BEACHES LINK AND GORE HILL FREEWAY CONNECTION ENVIRONMENTAL IMPACT ASSESSMENT

OBJECTION SUBMITTED BY EDWARD PRECINCT, NORTH SYDNEY
edwardprecinct@iinet.net.au

Submitted on 28 February 2021

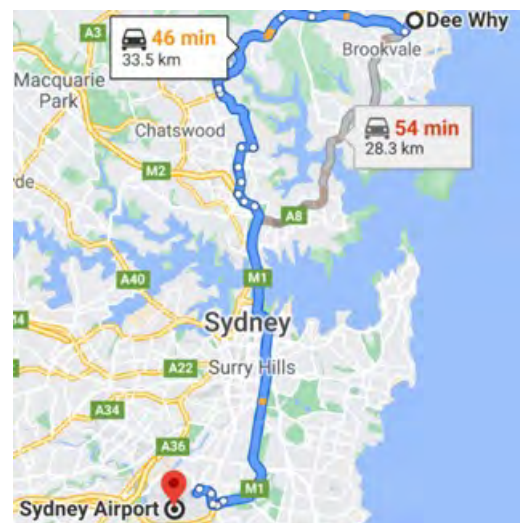
This only appears to relate to peak hour trips. A check on Google Maps indicates that at 3:00 PM on Tuesday 5 January, the time for the trip is estimated at 46 minutes so less than the total quoted time saving.

At 5:00 PM, the Google trip time would be 85 minutes making the suggested time saving indicated possible if speed averages 80 kph, but still optimistic. Since many people try to travel to the airport at non-peak times, the time saving estimate is highly inaccurate overall and needs to be reviewed.

Figure 4-1 Alternatives development process

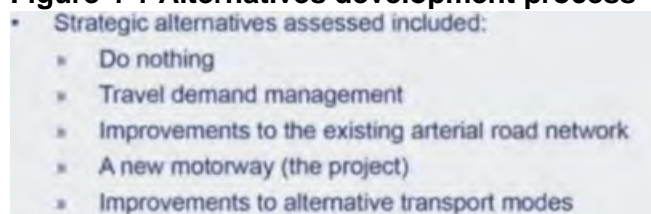
It is noted that while the figure mentions “improvements to alternative transport modes” it does not include addition of a new transport mode, ie, rail.

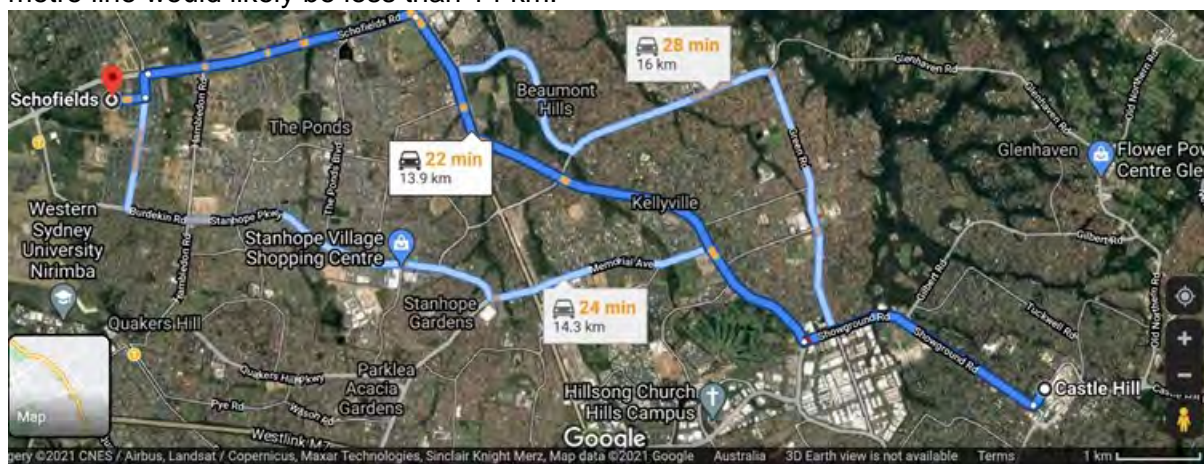
Shows the Sydney Metro Northwest line, recently completed. Looking at the line from Castle Hill to Schofields, it would appear to be similar in length to a possible new line from North Sydney or Chatswood to Dee Why or further north. The population served by the line is not known but is likely to be similar to that potentially served by a new line serving the northern beaches. Cost of the northern beaches line would be higher due to higher tunnelling needs and topographic issues, but nonetheless, if the Northwest line is economic, it is likely that a beaches line would be, and certainly merits serious consideration.

The following Google map shows the road connection from Castle Hill to Schofields, with a length of around 14 km. North Sydney to Dee Why via Spit Bridge is 15 km. A tunnelled metro line would likely be less than 14 km.

Figure 21-2 Eastern Precinct (p 21-5)

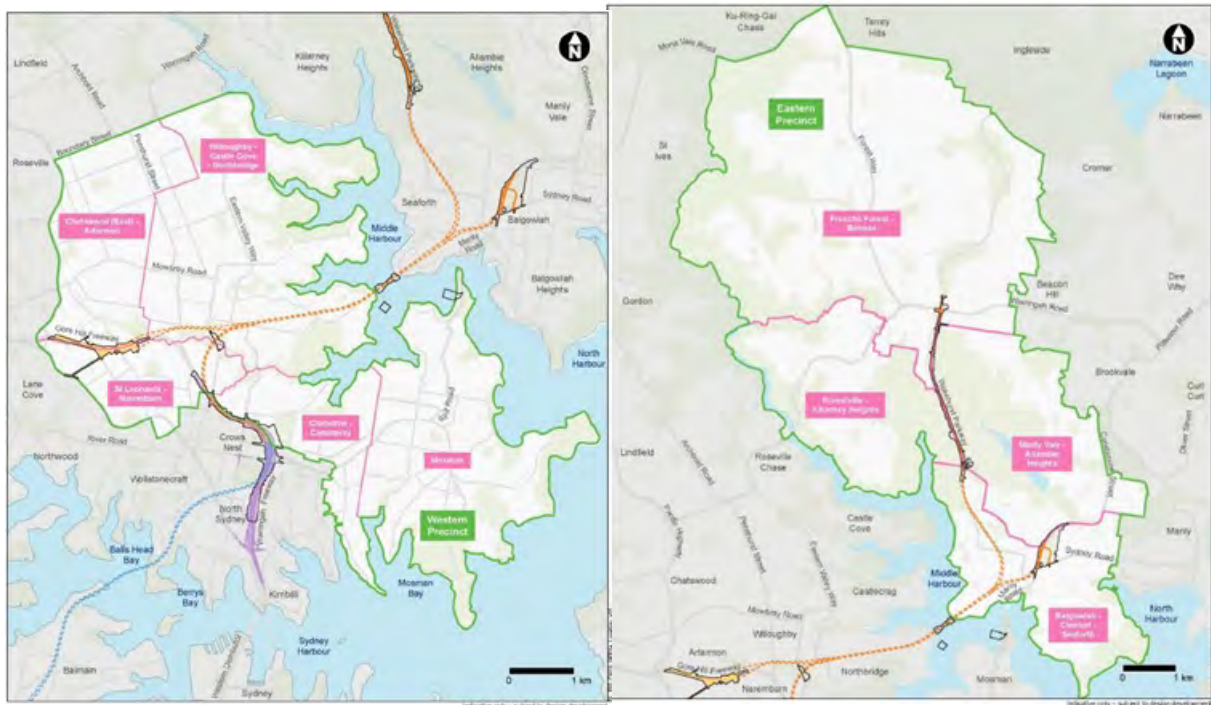
The EIS assumes that the Eastern Precinct includes Frenchs Forest, Belrose, Forestville, Killarney Heights, Manly Vale, Balgowlah, Clontarf and Seaforth with a population estimated at 80,000 in 2019 (Table 21-3). It is not clear why the precinct includes Frenchs Forest, much of which is far removed from the Wakehurst Parkway upgrade. None of the northern beaches suburbs are included in the precinct (see the map below).

Based on these figures, the road appears not to be designed to service the northern beaches and residents from Manly to Brookvale to Dee Why to Mona Vale will not benefit significantly from this road.
